| DOCKETED | |
|-------------------------|-------------------------------------|
| Project Title: | Puente Power Project |
| Document Title: | Data Adequacy Supplemental Response |

Subject: Puente Power Project (15-AFC-01)

Data Adequacy Supplemental Response

REVISED FIGURE 2.7-5a

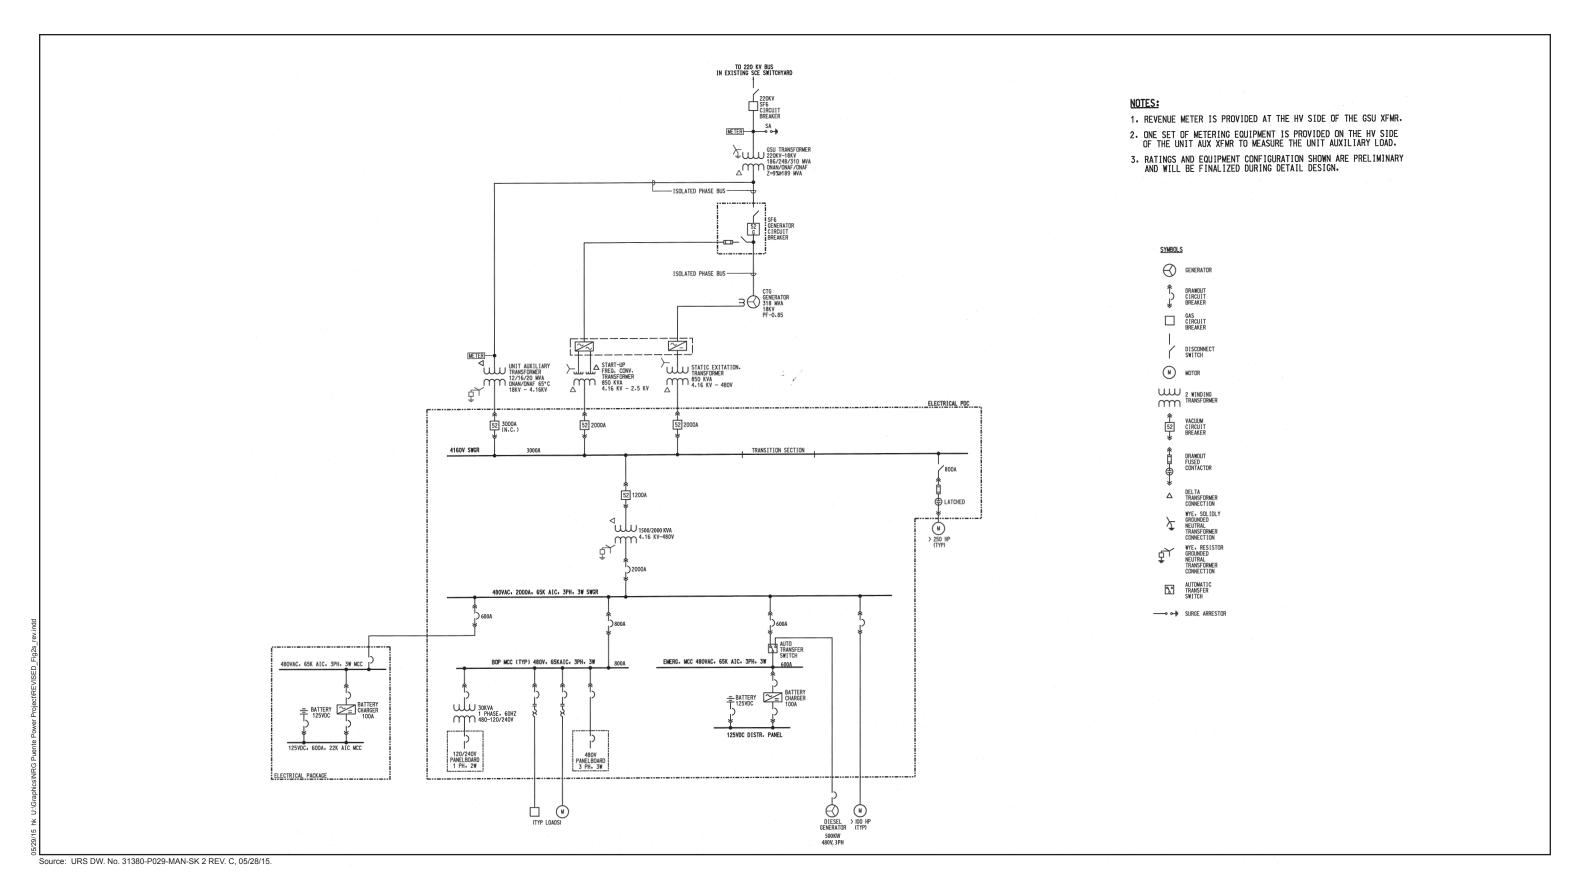
- 1. Resubmit Figure 2.7-5a. Show all equipment ratings including bay arrangement of the breakers, disconnect switches, buses, and etc. which are required for the addition of the project.
- 2. Resubmit Figure 2.7-5b. Show all equipment ratings including generators, transformers, isolated phase bus, circuit breakers, disconnect switches, and etc. which required for the project.

- 1. See attached Revised Figure 2.7-5a.
- 2. See attached Revised Figure 2.7-5b.
